REPORT AMENDED BY STAFF 1-22-87
CITY PLANNING COMMISSION

APPLICATION: Special Permit to allow the construction of a 24-hour convenience store.

LOCATION: 1235 Florin Road

PROPOSAL: The applicant is requesting the necessary entitlements to construct a 24-hour convenience store in conjunction with the remodeling of an existing service station.

SITE PLAN

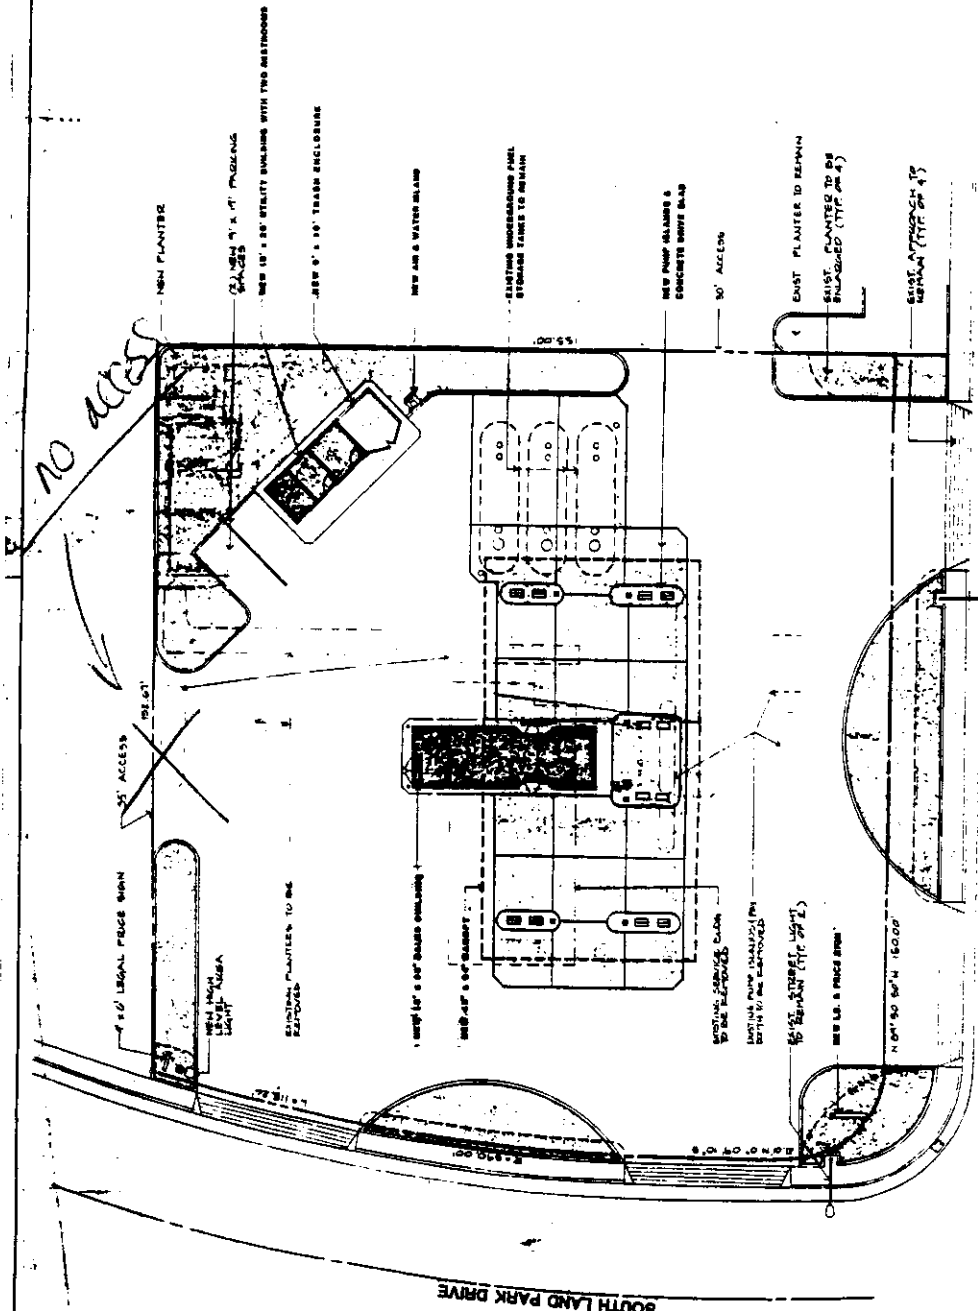
- C. Staff has reviewed the applicant's site plan building elevations and landscape plan. The following are highlights of the proposal which will require modification:

1. Staff recommends that the proposed planter strip along the north property line be more heavily landscaped with evergreen trees in addition to the single oak. Additional evergreen trees would screen the glare of headlights on adjacent properties and South Land Park Drive. ~~There/ should be no access through the north side of the site/~~ (staff amended)

1. The applicant shall submit a revised landscape plan, indicating evergreen tree plantings along the north property line. For review and approval by the Planning Director prior to the issuance of any building permits.
2. The applicant shall obtain a revocable encroachment permit from the City for the planter areas which are to be located in the City right-of-way prior to the issuance of building permits.
3. The applicant shall obtain the necessary permits from the Building Division to demolish the existing service station.
4. ~~There shall be no access through the north side of the site.~~ (staff deleted)

ID. & PRICE SIGNS
1/4" = 1'-0"

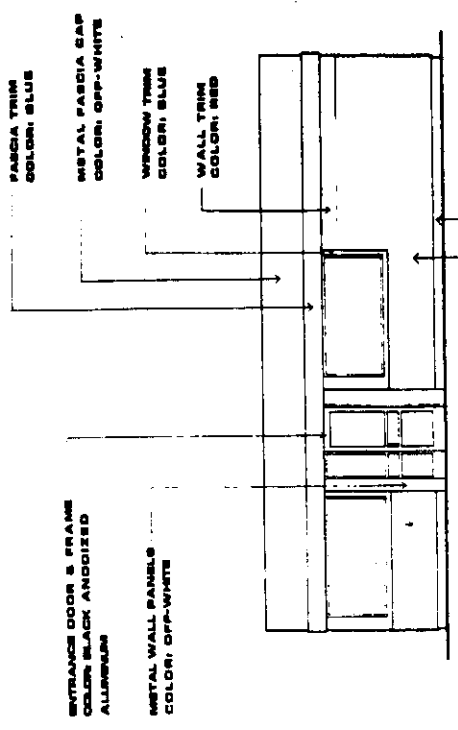
- E. On-site signage would include a 30 foot high pole I.D./price sign (110+ sq. ft.). The new sign will replace existing pole sign. In addition, two 4' X 6' price signs will be located facing each street frontage. Under the Business and Professions Code, the station operator is required to have at least one price sign per street frontage. Since the signage is consistent with existing sign design in the area and since the price signs are legally required, staff has no objections.
